UNITED STATES PATENT AND TRADEMARK OFFICE

APPLICATION NO.	FILING DATE	FIRST NAMED INVENTOR	ATTORNEY DOCKET NO.	CONFIRMATION NO.
10/767,599	01/30/2004	Bernardo Ayala	BA01-01U	5201
37038	7590	07/05/2005	EXAMINER	
BUHLER ASSOCIATES BUHLER, KIRK A. 2687 SCENIC CREST LANE CORONA, CA 92881			ROYAL, PAUL	
			ART UNIT	PAPER NUMBER
			3611

Office Action Summary

DETAILED ACTION

Sheet 2 of 5

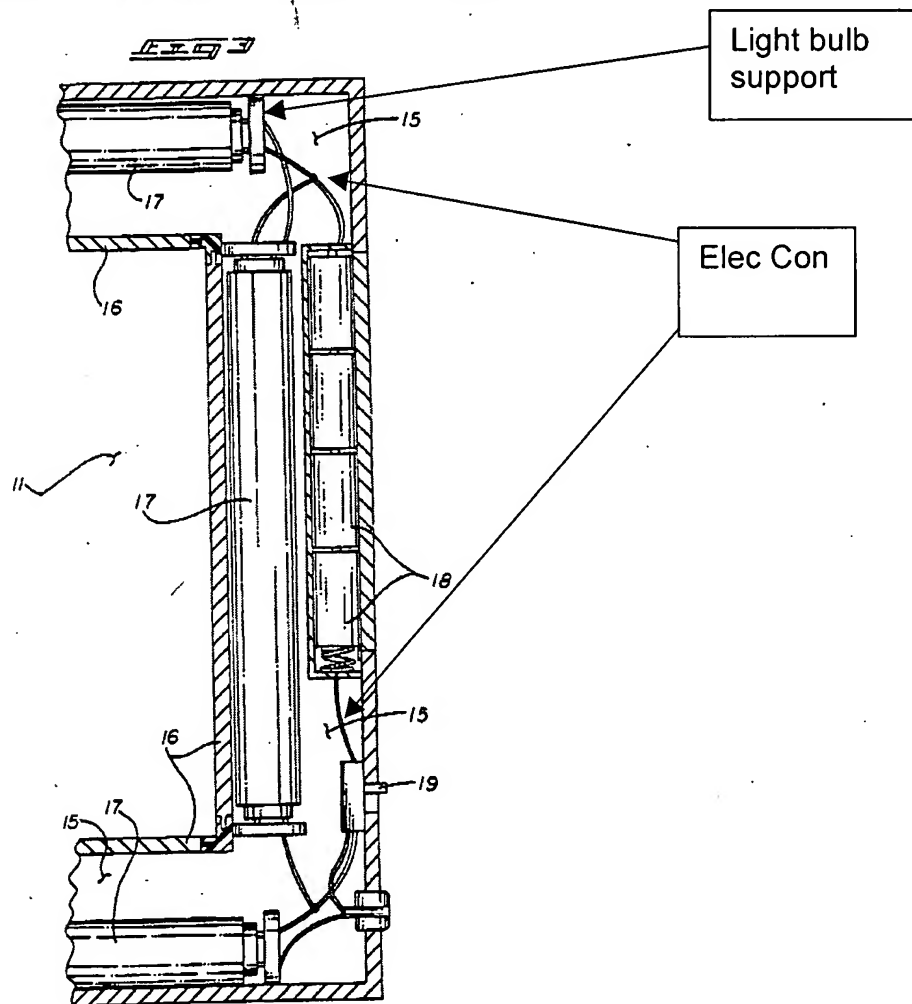
a frame structure (12) capable of retaining a replaceable image (11),
at least one power storage device/battery (18) located within the frame structure (12), as well as an external power source (20) located external to the frame structure,

a power control device (19) located within the frame structure (12),

at least one light source (17) located in front of the image located within the frame structure such that light can shine on the front of the image, and

an electrical connection (Elec Con, see Examiner's annotated Figure 3) located within the frame structure as part of the frame structure that connects the power control mechanism/device (19) and the light source (17).

Note the wiring and light bulb support (see Examiner's annotated Figure 3) are considered part of the frame structure where they are attached to the frame structure.

Further, note that Warner is understood to teach the frame structure is made from metal where in Figure 3 of the drawings of Warner, which are part of the specification, the frame cross-hatching represents metal.
